Groundwater Application Review Summary Form

Application # G- 18350 - Renew #2

SUBJECT: Application G- 18350 Supersedes review of October 23, 2017
Date of Review(s)

A. GENERAL INFORMATION: Applicant's Name: XP Investments LLC County: Jackson

Partially penetrating stream with streambed resistance (Hunt, 1999)

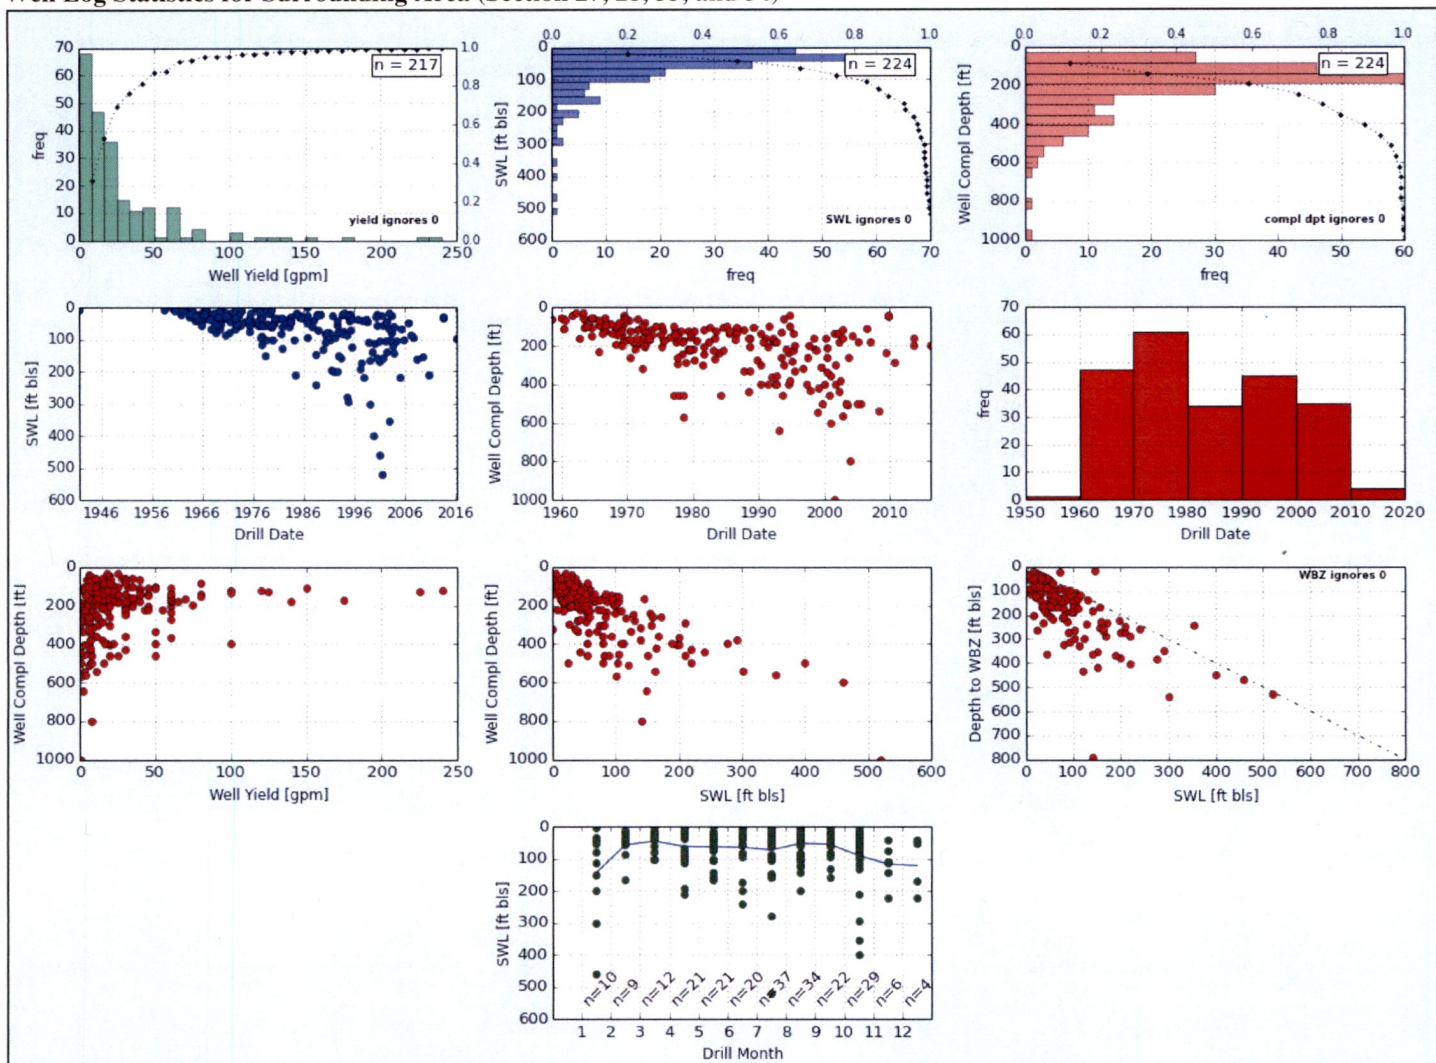
Comments: Interference with surface water was estimated using the Hunt (1999) stream-depletion model run through the USGS Michigan Water Science Center web-based version. The model was run using parameter values expected for this type of geology. The model input page is attached and the website can be found at:

^A Only Well #2 (JACK 2916) was evaluated for PSI because it is the closest to the impacted surface water. Interference is inversely-proportional to distance so all other wells will have less interference with surface water

^B Monthly Well Q was based on the annual duty (5 AF/yr/acre x 78.2 acres) divided by the period of use (12 months)
